DATE: July 17, 2013

AGENDA ITEM # 2

TO: Design Review Commission
FROM: Sierra Davis, Assistant Planner
SUBJECT: 13-SC-10 – 691 Benvenue Avenue

3.1 Plan, with tree numbers added

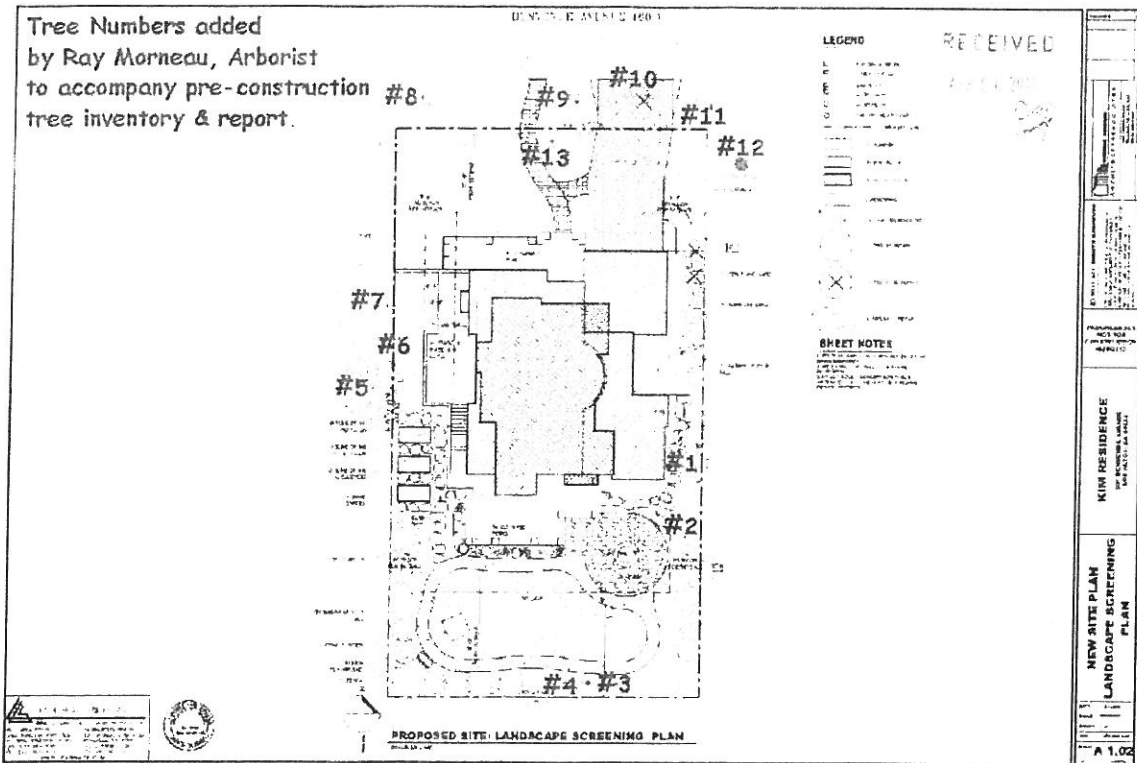
All the trees, except magnolia #10 in the new driveway footprint, can be preserved, per current site plan, A 1.02.
